PLANNING COMMITTEE Regulatory Committee Agenda

APPLICATION REPORT - HH/345153/20

Proposal: Two storey rear extension
Location: 2 Lower Tunstead, Tunstead Lane, Greenfield, OL3 7NT
Case Officer: Sophie Leech

Application Nos. HH/345153/20 & LB/345154/20

PROJECT
PROPOSED REAR DORMER AND NEW GABLE WALL.
DRAWING TITLE
PROPOSED LAYOUTS AND SECTION.
CLIENT
MR. S. AMIN.
ADDRESS
8, ELGIN ROAD,
GLODWIN, OLDHAM.
SCALE DATE
SCALE 1:50@A1. OCT 2019.
DRAWING No
JK 10195500/2.

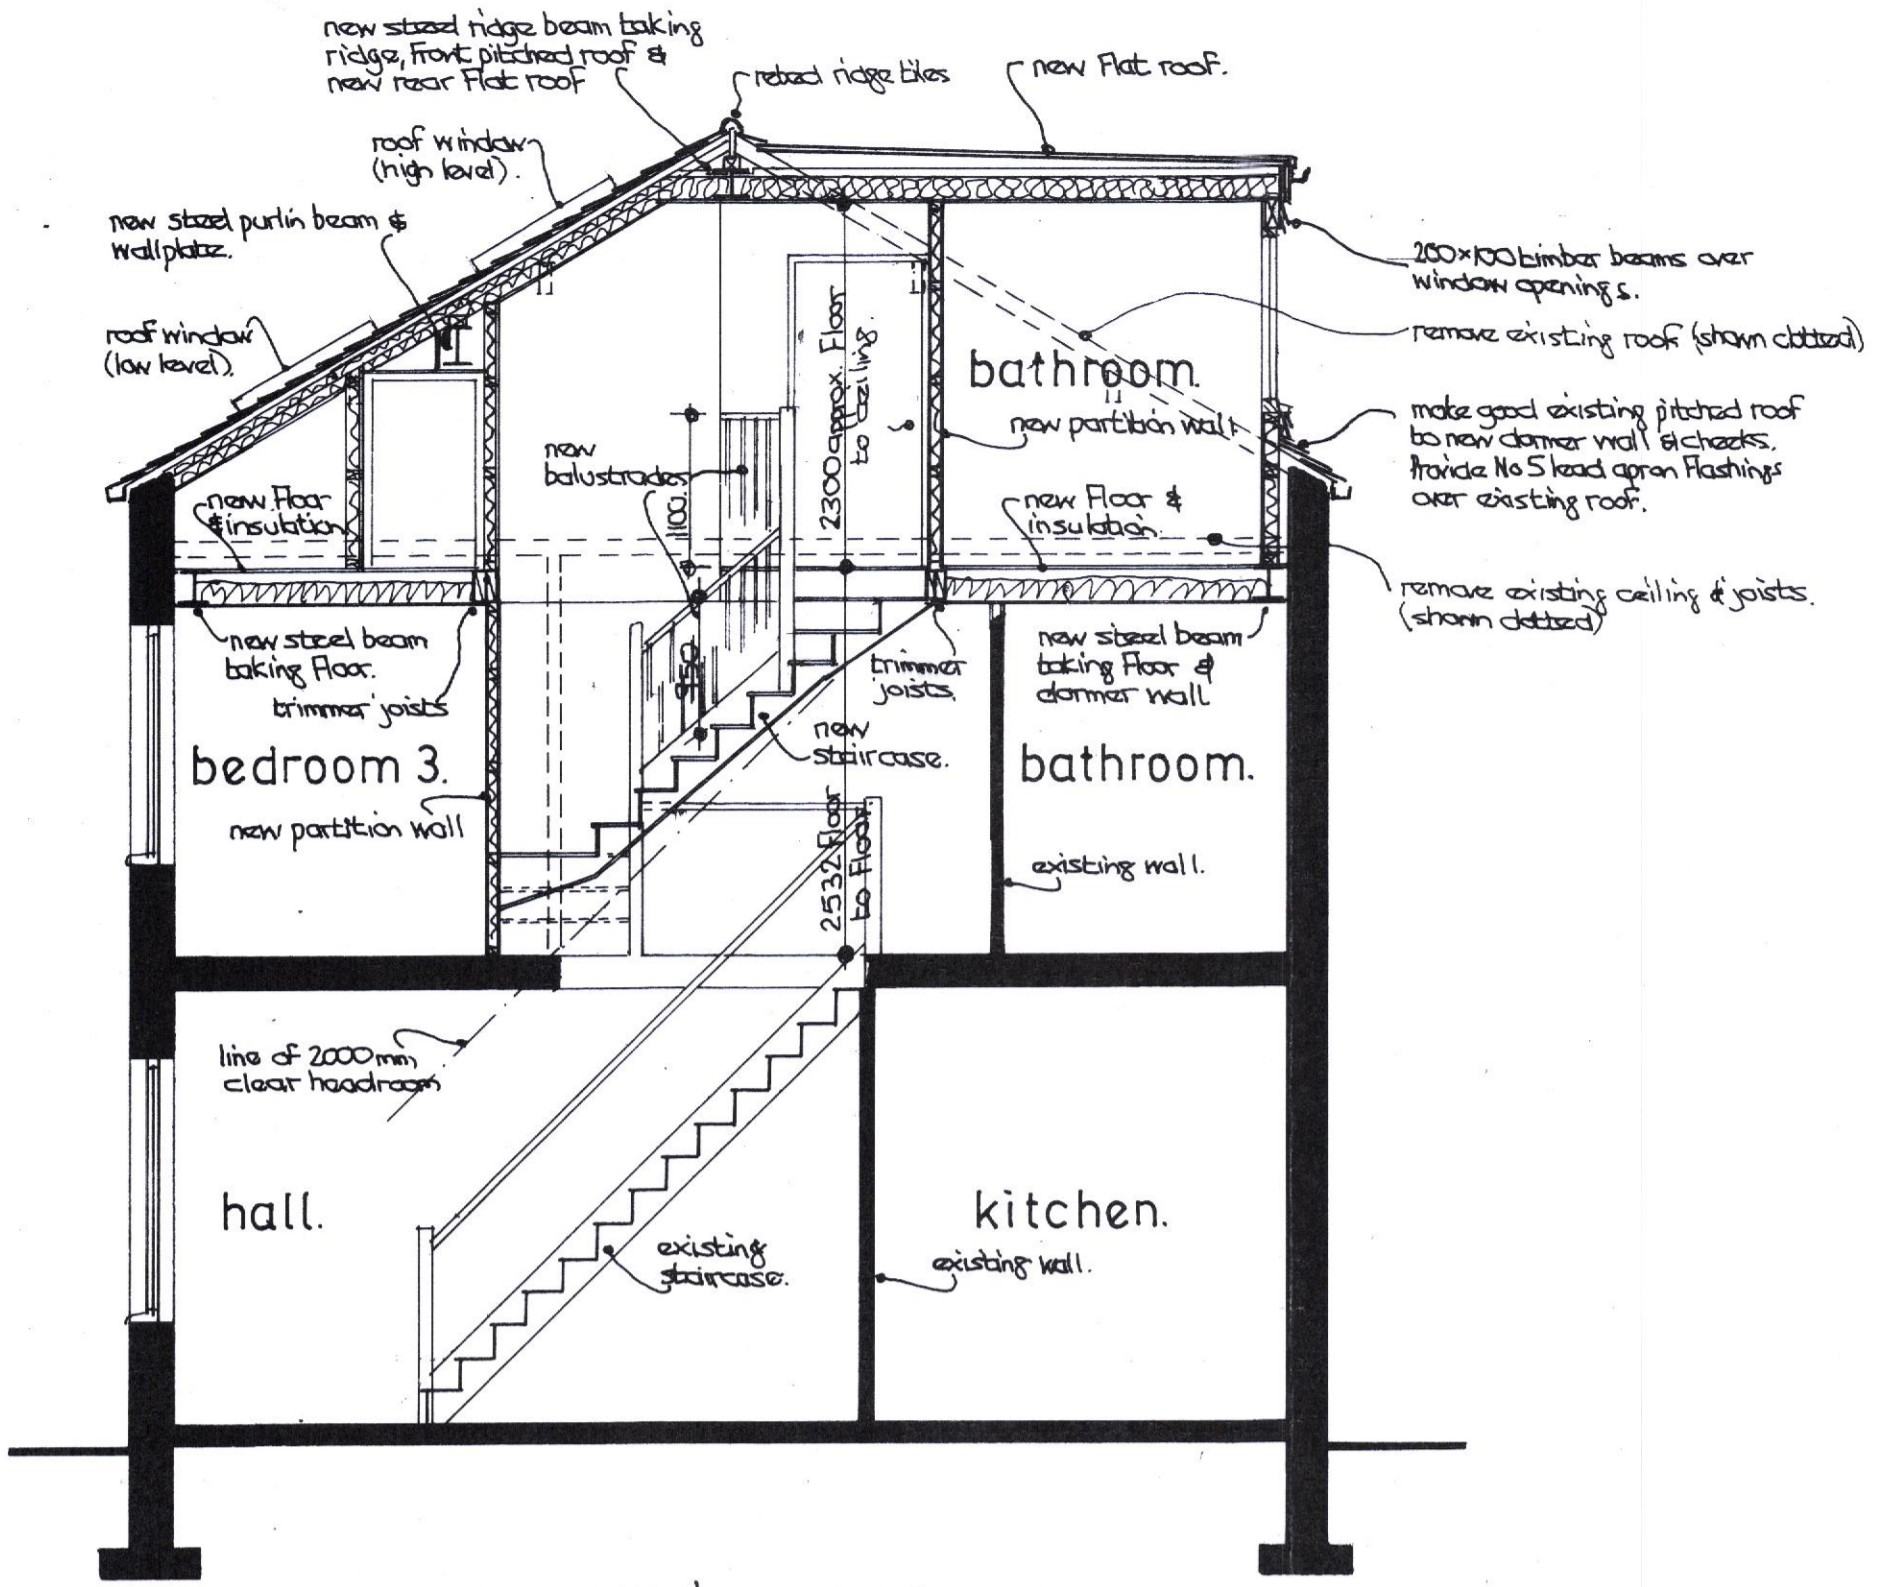
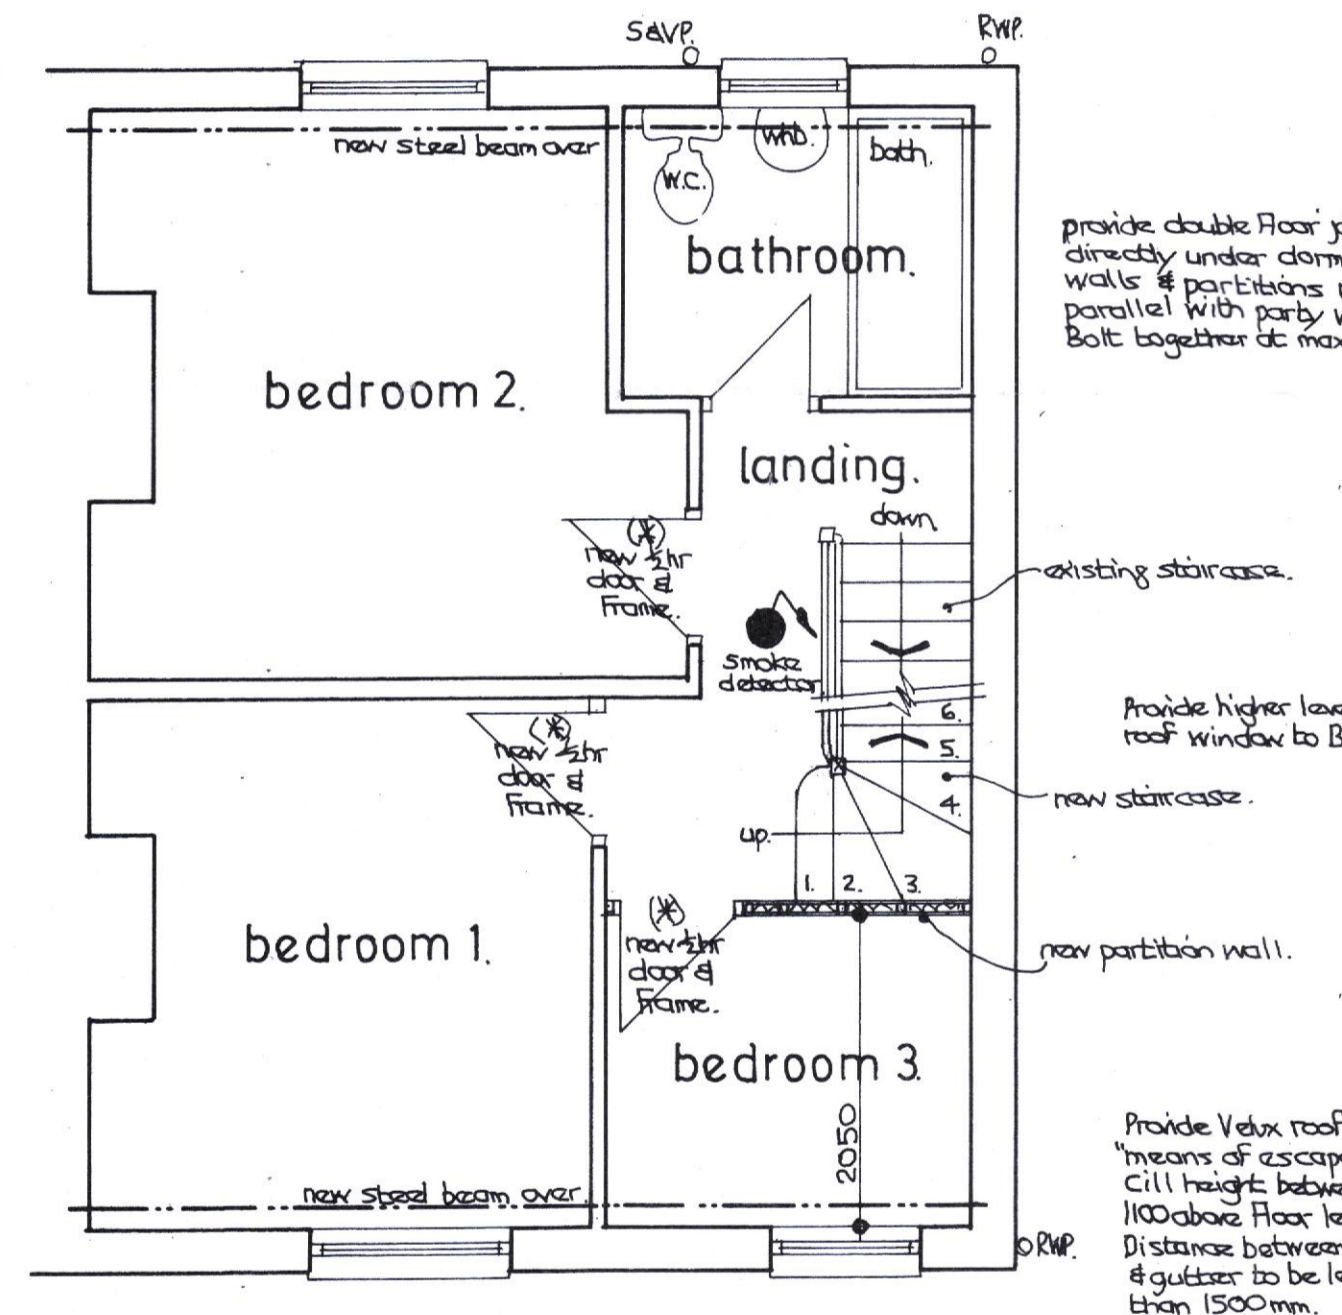
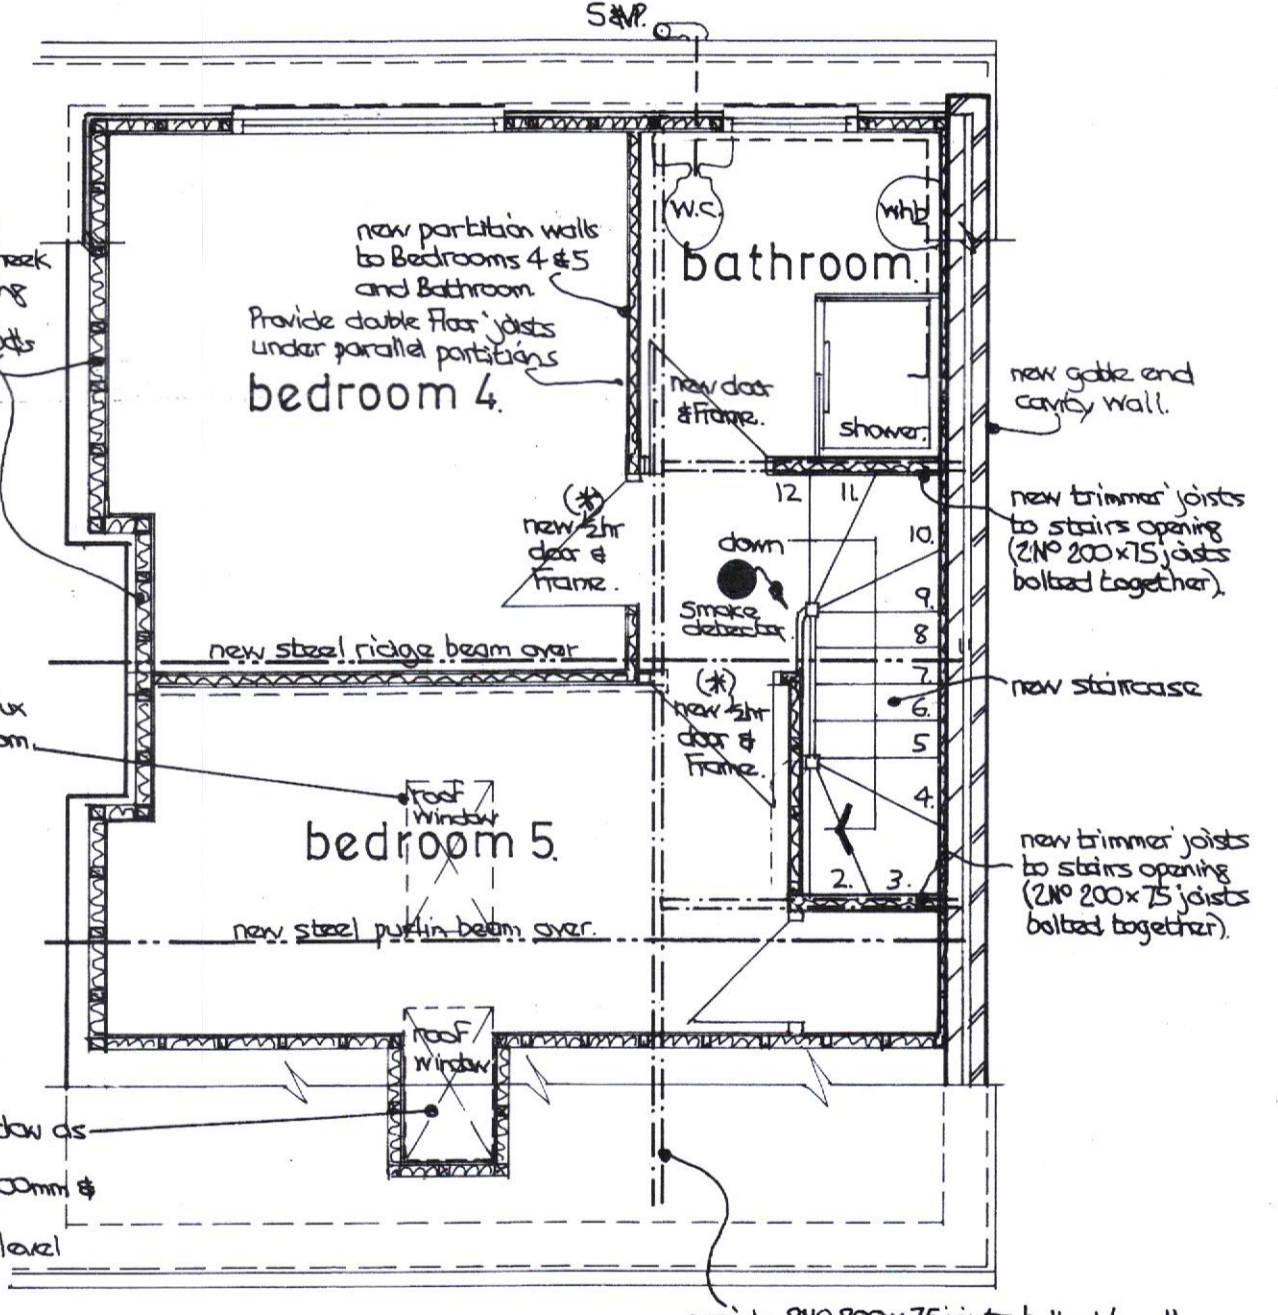
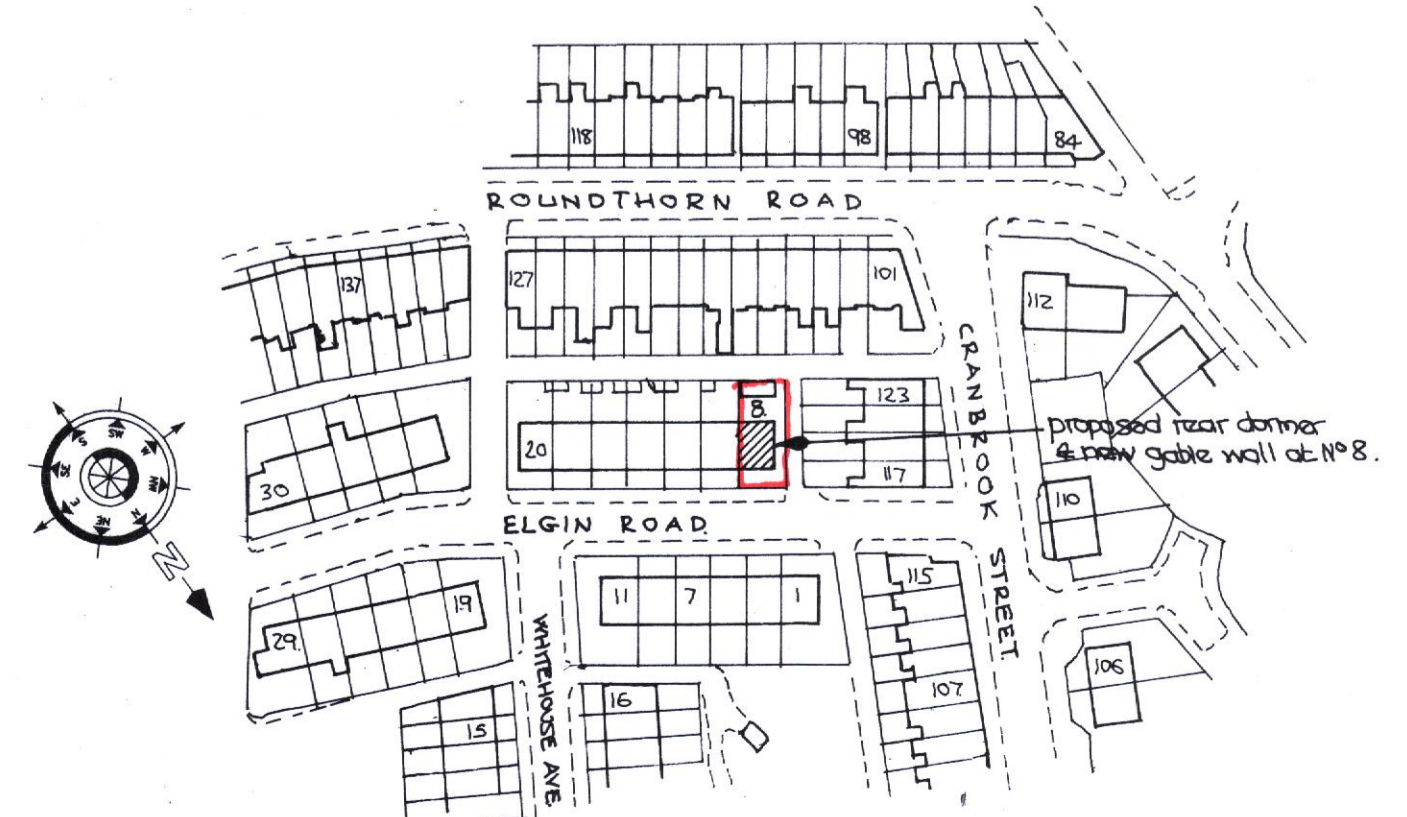
6. However, the proposed dormer would be constructed with a side wall flush with the gable. The angular extent of brickwork projecting above the perceived roof slope would appear as a stark and obtrusive feature which would give the resulting building an incongruous and top-heavy character. Due to the end of terrace location, this unsympathetic addition to the property would be readily visible from the public realm. Whilst this specific design may not be expressly prohibited by planning policy, the effect on character and appearance is a matter of planning judgement and the lack of a prescriptive policy does not lead me to a different conclusion in respect of the harm arising from the proposal.

8. Notwithstanding my conclusions in respect of the proposed gable roof, I conclude that the use of a flush side wall for the dormer would lead to significant harm to the character and appearance of the host building and the area. The proposal would therefore be contrary to the design and visual amenity requirements of Policies 9 and 20 of the Oldham Joint Core Strategy and Development Management Policies 2011. The proposal would also be contrary to the National Planning Policy Framework with regards to achieving well-designed places.
